SUBJECT: Additional information to TD check

PDC-1E

SUBJECT: Exposure lamp position

SUBJECT: 1st and 2nd synchronizing mirrors installation procedure

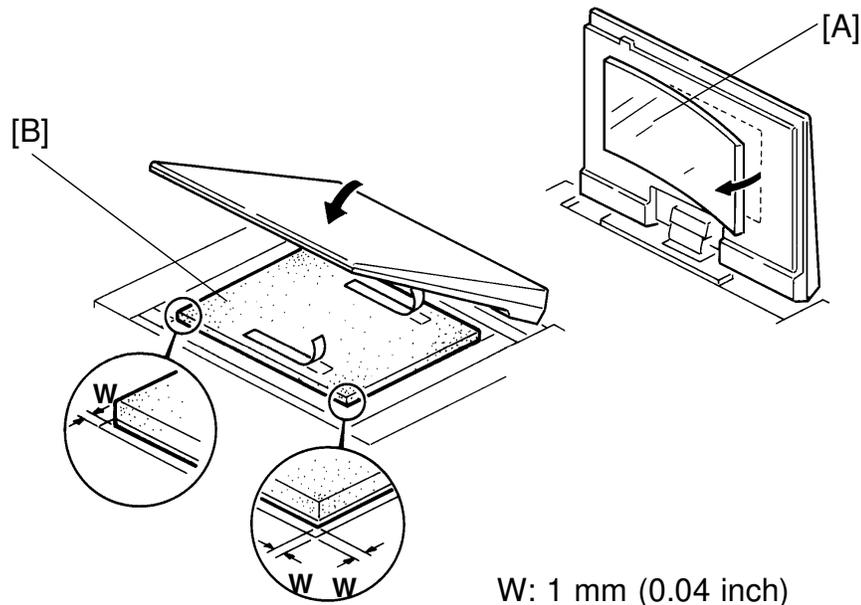
1. Remove the pressure pad [A] from the editor board.

2. Put the new pressure pad [B] as shown in the illustration. Make a **1mm (0.04 inch)** space between the front scale and the front edge of the pressure pad, and between the right scale and the right side of the pressure pad.
3. Peel off the cover from the two adhesive tapes, close the editor board and press the editor board by hand. Especially, press the part directly above the tapes.
4. Confirm that there is no blurred image on the copy.

We have changed the material of the pressure pad from polypropylen to polycarbonate which does not deform at temperatures under 130°C (266°F).

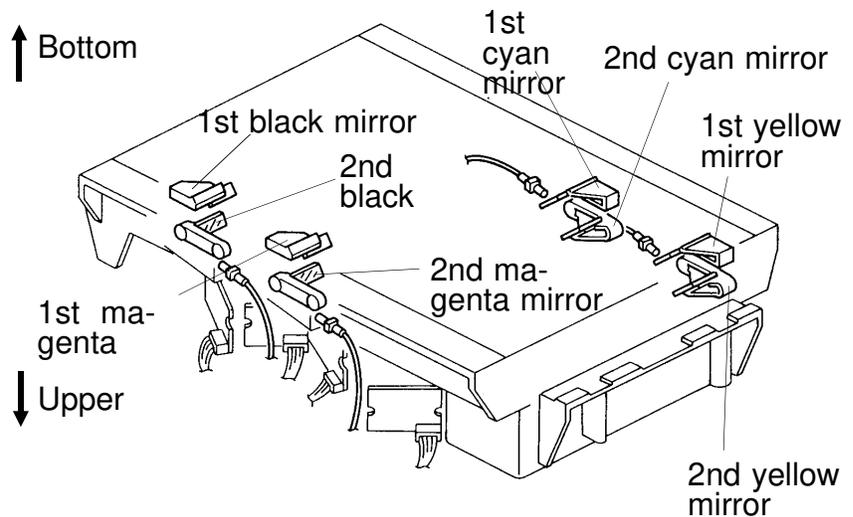
7. Confirm the location of each synchronizing mirror and confirm which mirror should be removed.

8. Remove the fiber cable bracket [F] corresponding to the position of the mirror to be removed. (3 screws)

To reduce the service cost and meet the field requests, the 1st and 2nd synchronizing mirrors have been registered as service parts as follows:

- 1st synchronizing mirror [G] -

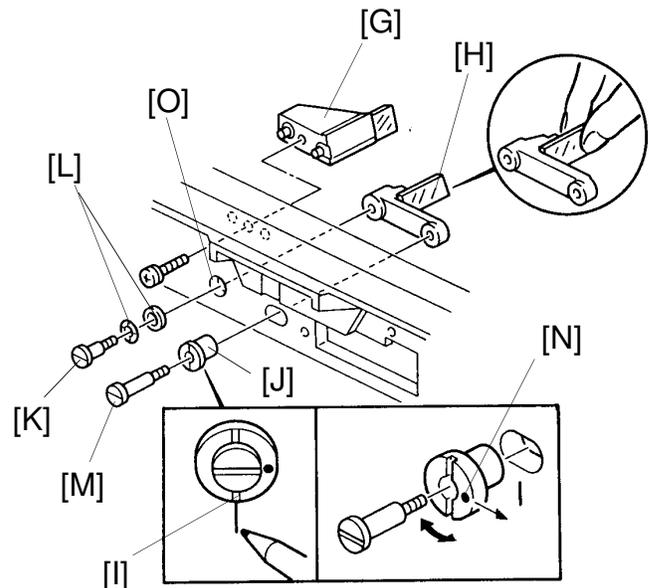
9. Remove the 1st synchronizing mirror. (1 screw)

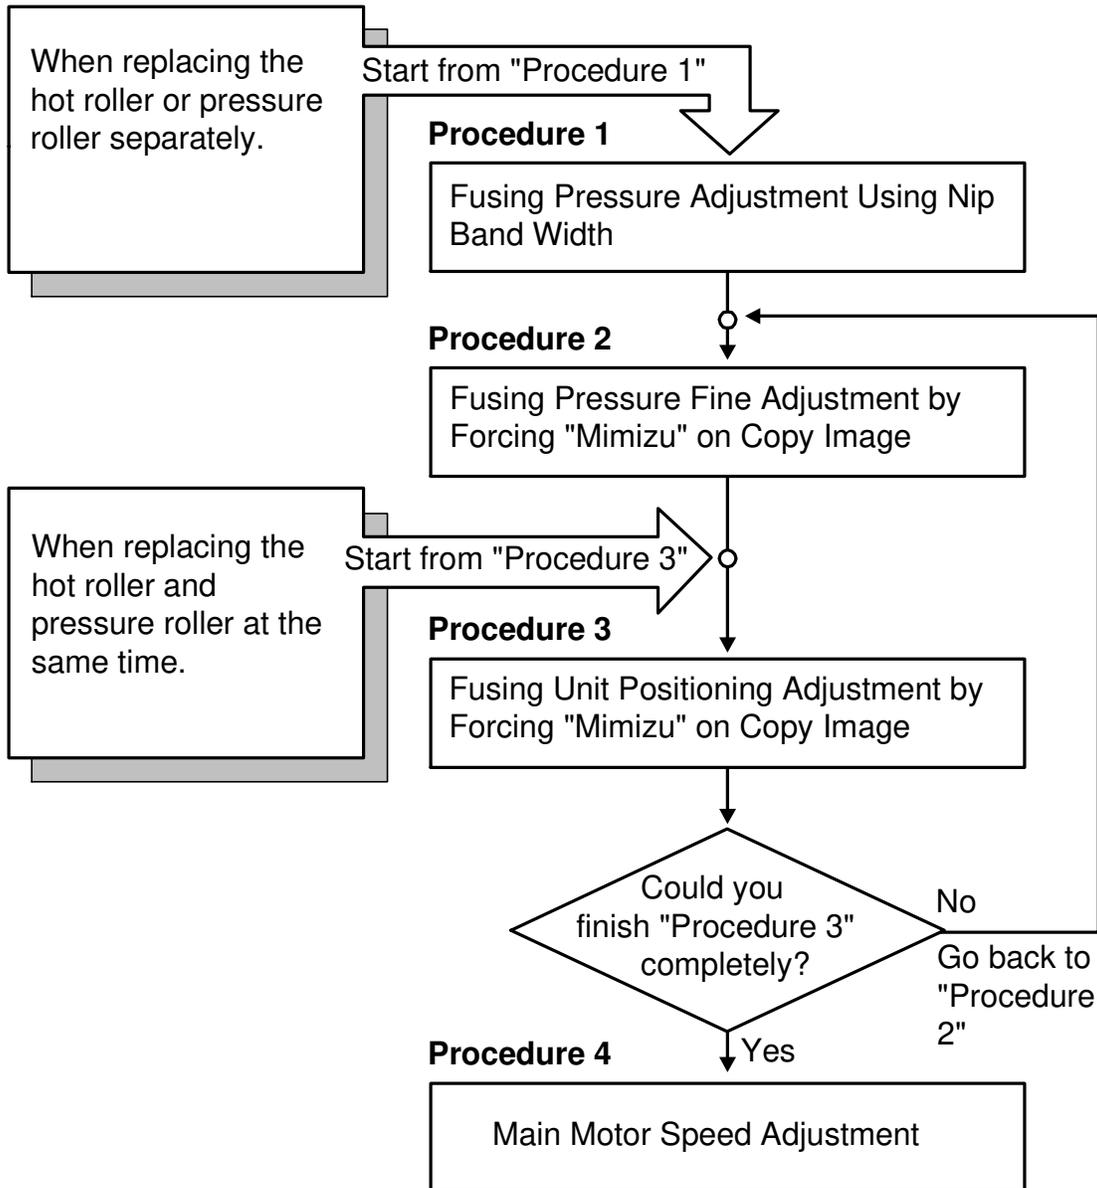
Old P/N	New P/N	Description	Modified Point
AE010005	AE010008	Hot Roller	The hardness of the rubber has been decreased. The diameter has been changed from 44.7 mm to 44.5 mm.
AE020018	AE020043	Pressure Roller	The hardness of the rubber has been increased.

When replacing the hot roller and/or pressure roller, the following procedure is required.

NOTE: We recommend replacing the hot roller and pressure roller at the same time in order to increase the expected life time of the hot roller.

Fig. 1

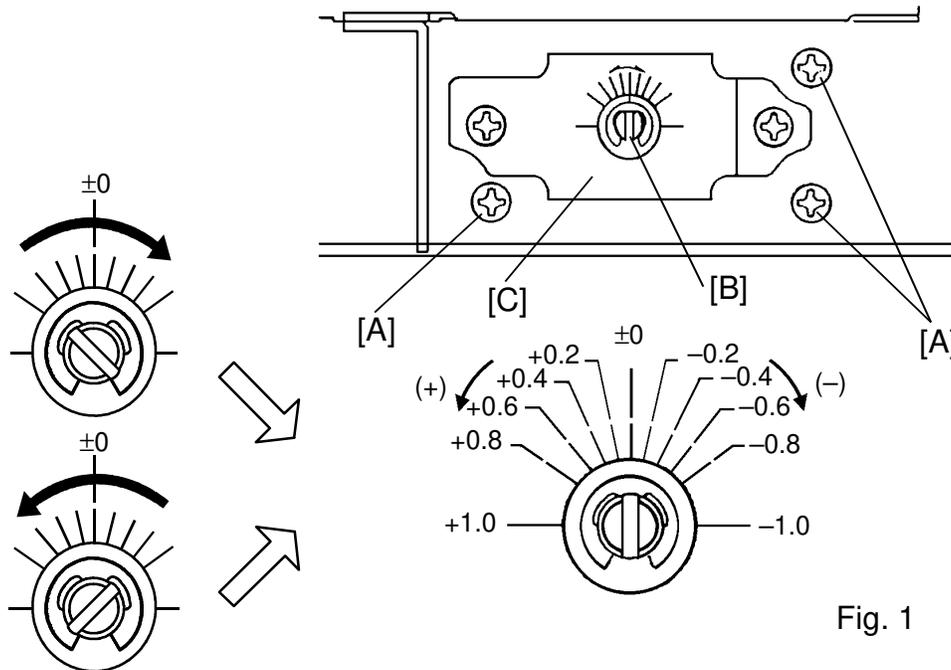
1. Loosen the screws [A]
2. Turn the adjustment cam [B] which points to the scale (± 0) on the bracket [C] as shown in figure 1.

Figure 2

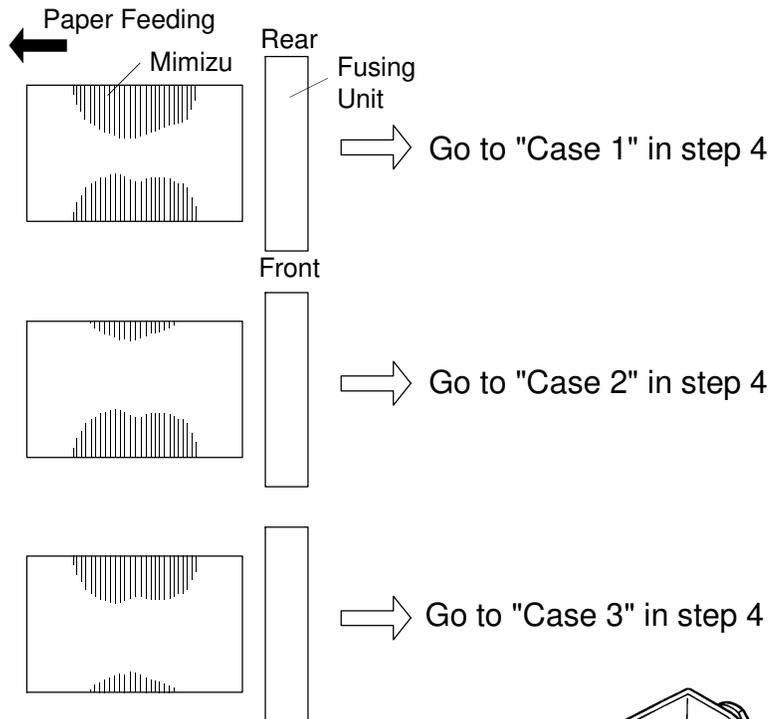
4. Confirm the location and size of the "Mimizu" patterns on the copy image. Then do the appropriate procedure (Case 1, Case 2, or Case 3). See Figure 2.

Figure 3

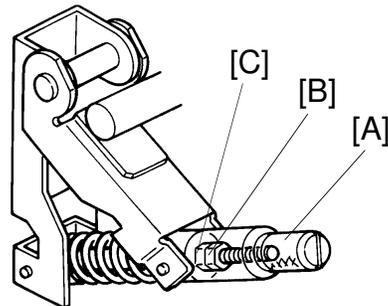
- 1) Remove the slotted screw [A] and the nut [B] at the **rear of the fusing unit**. See Figure 3 in the previous page.
- 2) Turn the nut [C] at the rear of the fusing unit 90 degrees clockwise.
- 3) Make 5 copies continuously.
- 4) Confirm the location and size of the "Mimizu" patterns on the copy image. Is the "Mimizu" pattern toward the rear the same size as that toward the front?
 - Yes: Go to **procedure 3**.
 - If not, do the appropriate procedure as follows **until** the "Mimizu" pattern toward the front is the same size as that toward rear:
 - No, the "Mimizu" pattern toward the rear is bigger than that toward the front:
 - Turn the nut [C] at the rear 45 degrees ~ 90 degrees clockwise.
 - No, the "Mimizu" pattern toward the rear is smaller than that toward the front:
 - Turn the nut [C] at the rear 45 degrees ~ 90 degrees counterclockwise.
 - Go to **procedure 3**.

Figure 1

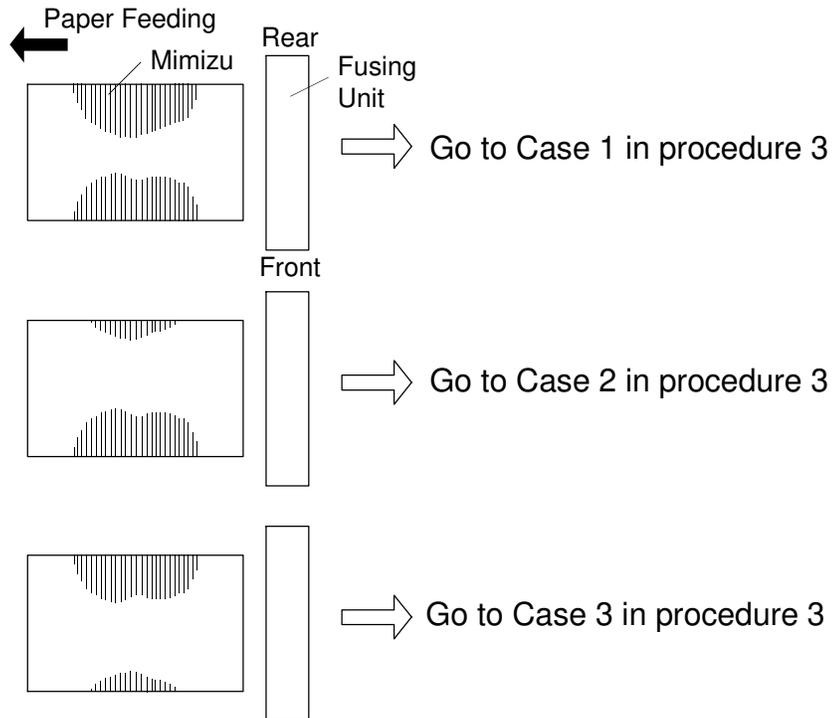
2. Confirm location and size of the "Mimizu" patterns on the copy image. Refer to figure 1, and choose the necessary procedure from the following:

Fig. 2

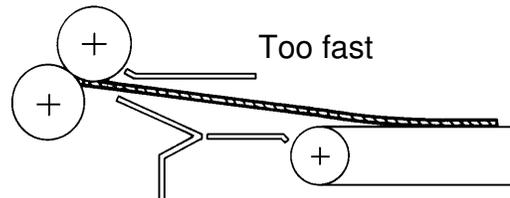
3. Observe the paper condition when the paper is pulled by the fusing rollers. If the paper is pulled strongly by the fusing rollers (figure 2), lower the speed of the fusing rollers by choosing a lower setting for SPD#720. If the paper buckles (figure 3), increase the speed of the fusing rollers by choosing a higher setting for SPD#720.

Fig. 3

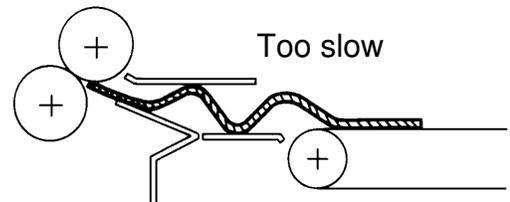
NOTE: In the case of figure 3, the copy image is scraped by the upper paper guide.
